Proposal for guidelines on the scope, administrative provisions and alternative requirements in Regulations annexed to the 1958 Agreement

OICA comments to ECE/TRANS/WP.29/2011/48

Figure 1

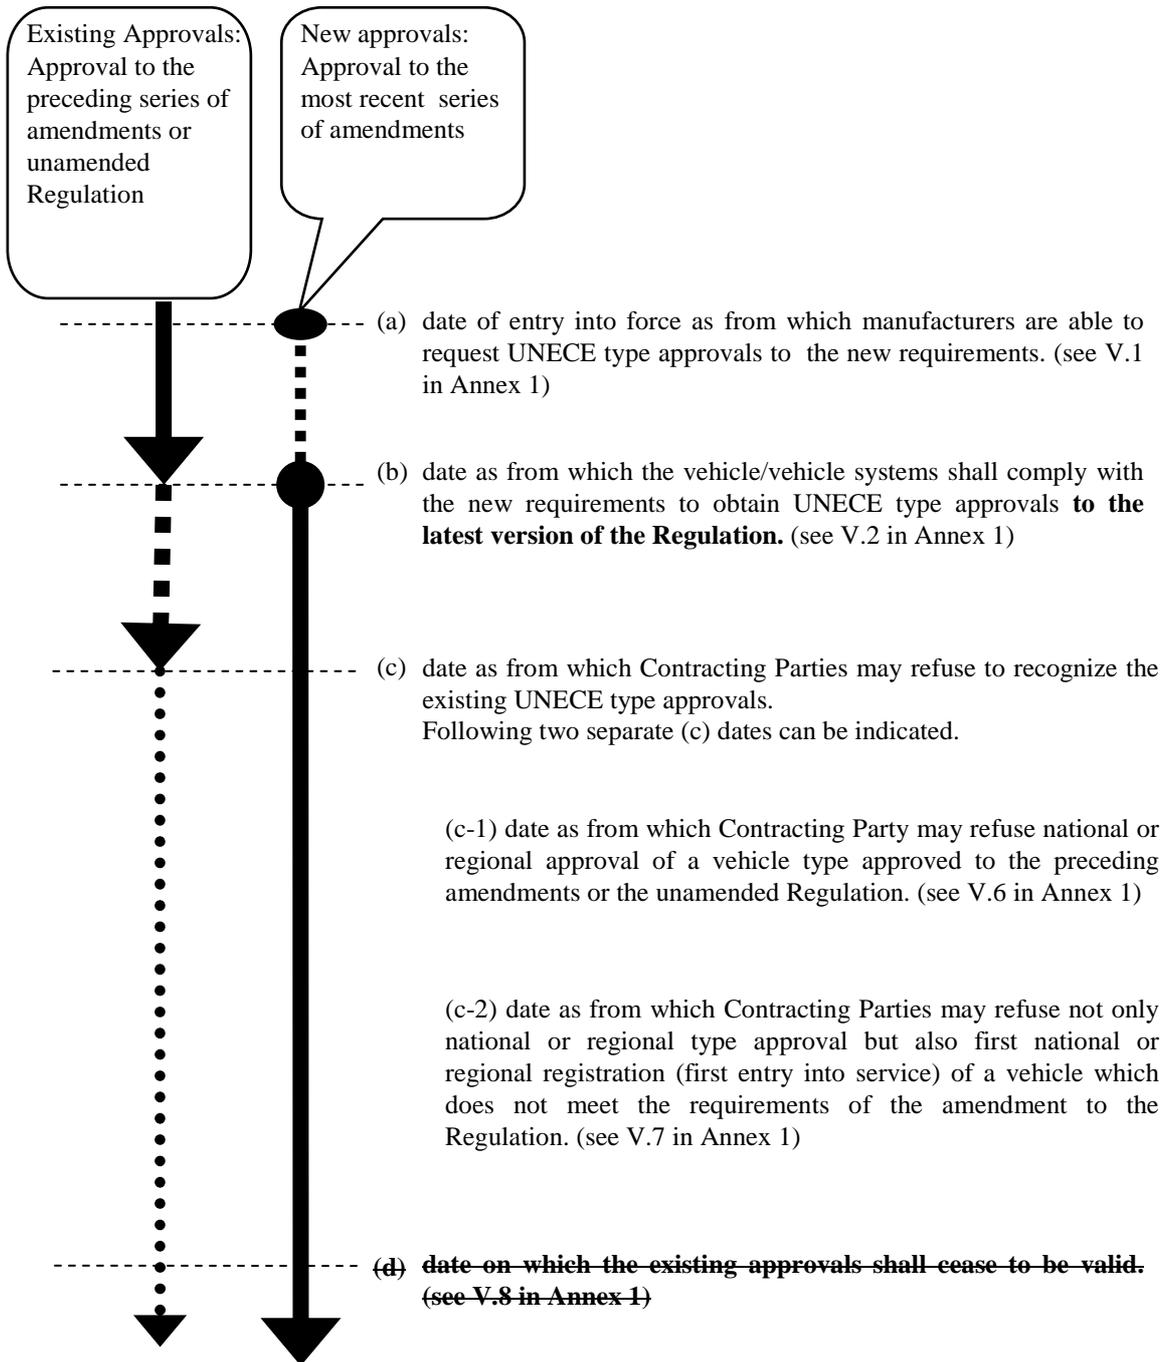
~~If date (d) is not written in the transitional provisions, the existing approvals can remain valid, but Contracting Parties are not obliged to accept them as from date (c).~~
